Architect's Supplemental Instructions

Architect's ASI No: 016

Project:
Webster University
Interdisciplinary Science
Building

SHEET E0201.A LEVEL 01 AREA A FLOOR PLAN – LIGHTING

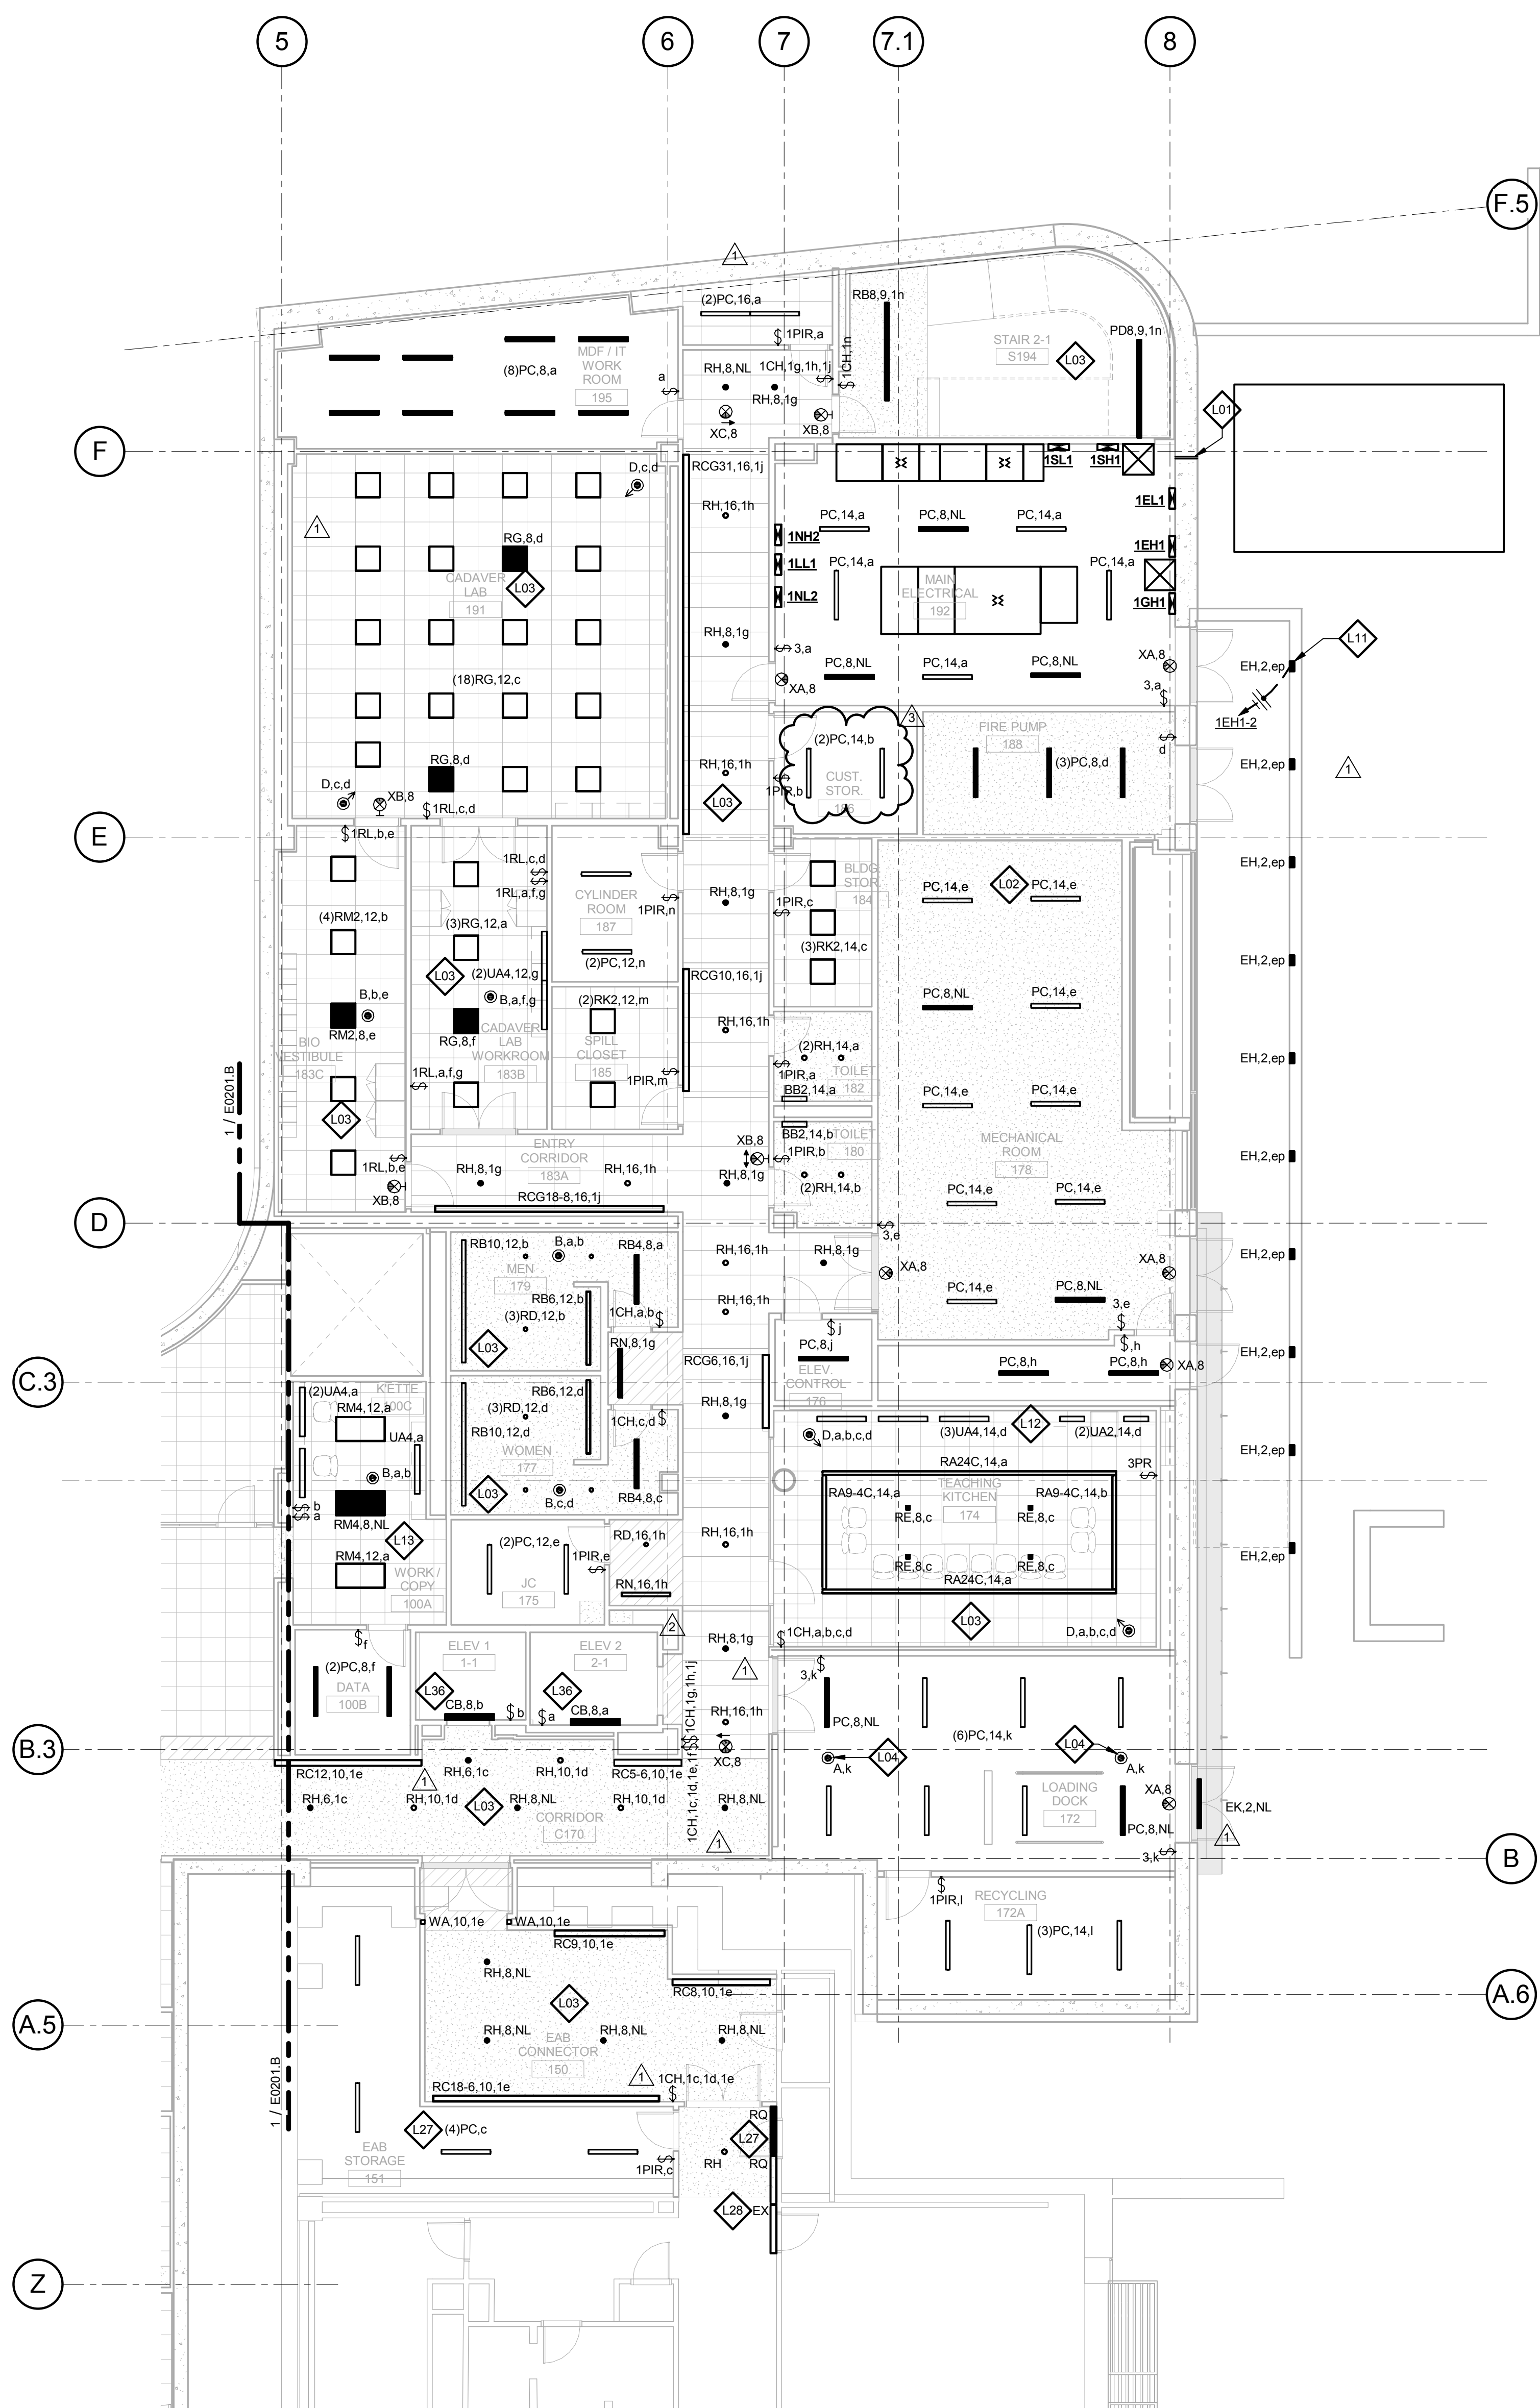
- In room 186, replace four (4) Type RK2 troffers with two (2) Type PC pendants due to a ceiling type change.
